October 19, 2006

ESH-WPG-2006-00132

### **Z-Area Industrial Solid Waste Landfill Vault Cracking (U)**

Attachment 2  
Vault Water Collection System

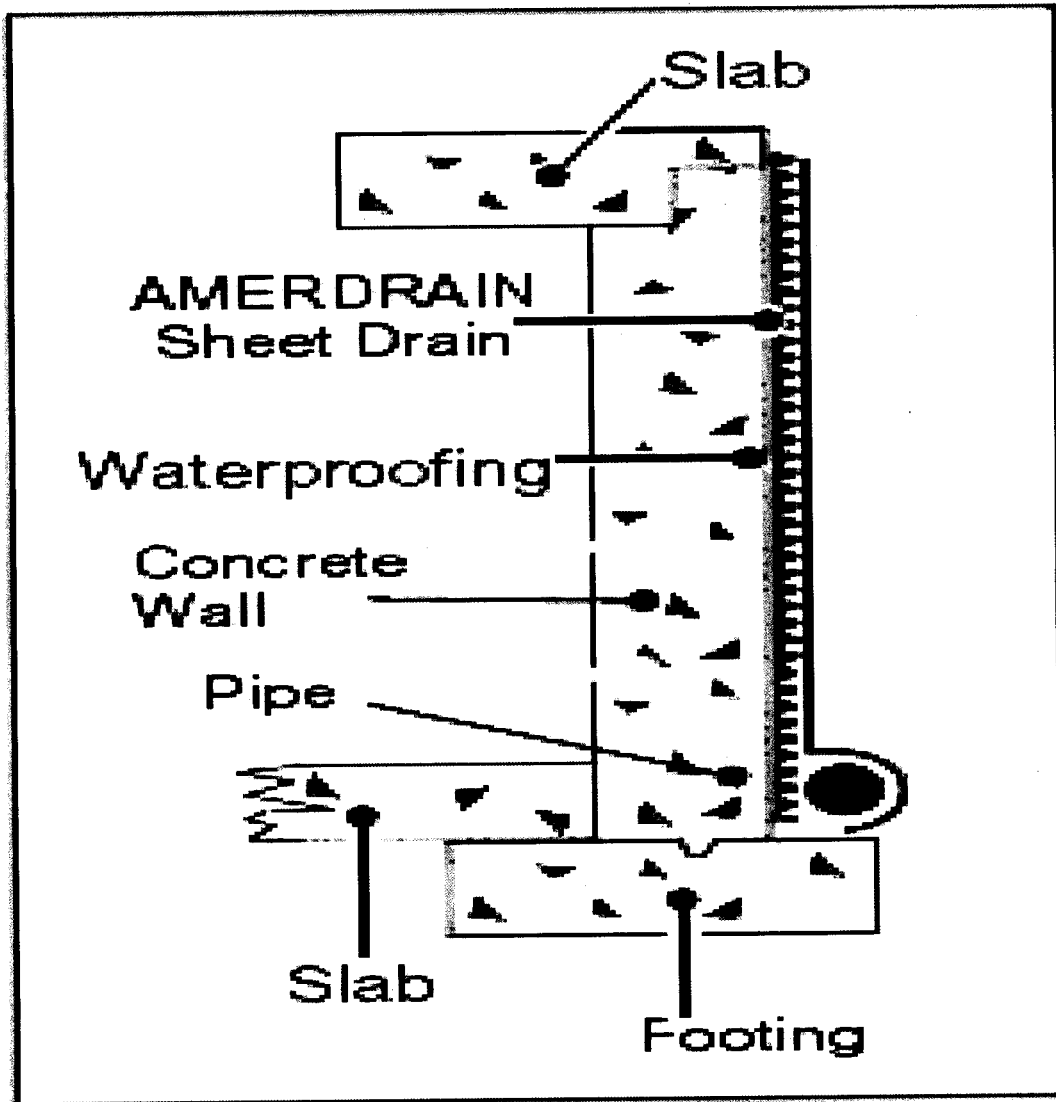
7. Explanation of how new design prevents cracks in the future, including pilot testing of sheet drain system.

In order to prevent weeping from vault cracks in the future the Vault Water Collection System has been installed in Vault 4 Cells B, D, E, F, H, J, K, and L. (See Attachments # 1, 2 and 3) This system is used for the collection and pumping of the excess liquid such as rainwater intrusion and bleed/process water from the Vault 4 cells back to the Salt Feed Tank in the SPF. A geotextile fabric membrane with an impervious backing is attached to the vault walls. Free liquid passes through the fabric where it is captured in the gap between the fabric and the backing. The water drains into a

PVC pipe system around the base perimeter of each vault cell. A drain line is connected to the PVC pipe through the Vault 4 wall which allows periodic draining of the liquid. The drain lines on each side of the vault are connected to a common header which is connected to a pump to transfer the excess water back to the Salt Feed Tank in the SPF. The interior surfaces of the outside walls are also coated with a waterproof coating up to a height of five feet, due to the fact that the vault walls are designed for gravity loads plus the hydrostatic pressure associated with the saltstone grout.

Extensive pilot testing of the Vault Water Collection System materials was conducted by the Savannah River National Laboratory to ensure that the System is adequate to remove the excess liquid from the vault cells. The test concluded that the Vault Water Collection System is adequately sized and will perform to remove excess liquid from the vault cells.

**Attachment 5**  
**Vault 1 and 4 Diagram**

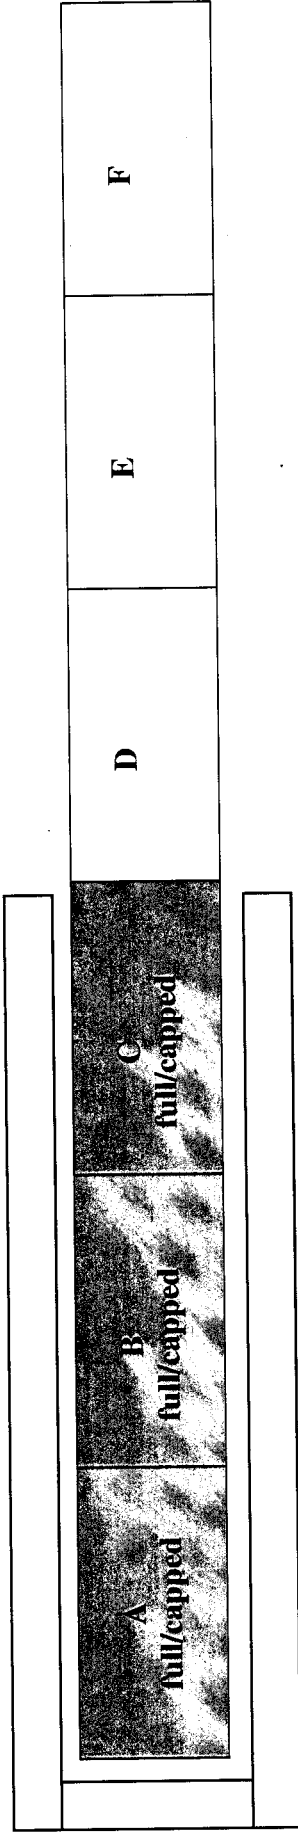
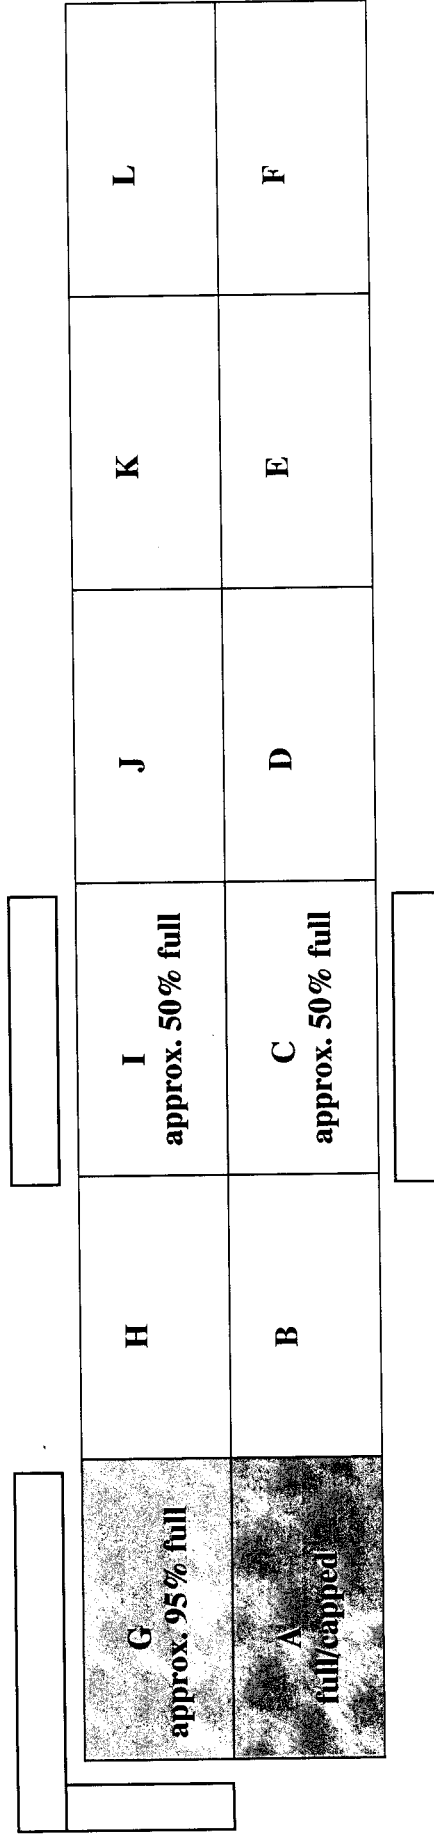
### 3. Diagram of vaults and soil contamination areas.

A diagram of Saltstone Vaults 1 and 4 is included in Attachment #5. Attachment #5 shows the cells which are full or partially full with grout and the empty cells.

As is shown in Attachment #5 the areas adjacent to Vault 1, Cells A, B, and C are posted as ICAs due to past operations. Periodic surveys are taken around the ICAs to confirm that there is no spread of contamination outside the posted area. Recent surveys outside the ICAs have found no spread of contamination. Plans are underway to survey inside the ICAs adjacent to Vault 1 to determine current radioactive contamination and radiation levels.

The area adjacent to Vault 4, Cell G is posted as an ICA. Periodic surveys are taken around the ICA to confirm no spread of contamination outside the posted area. Recent surveys outside the ICA have found no spread of contamination. (See Attachment #5) Plans are underway to survey inside the ICA adjacent to Vault 4, Cell G to determine current radioactive contamination and radiation levels.

The areas adjacent to Cells C and I are posted as ICAs due to previous operations and detection of contamination. Recent surveys outside the ICAs have found no spread of contamination. (See Attachment #5) Plans are underway to survey inside the ICAs adjacent to Vault 4, Cells C & I to determine current radioactive contamination and radiation levels.
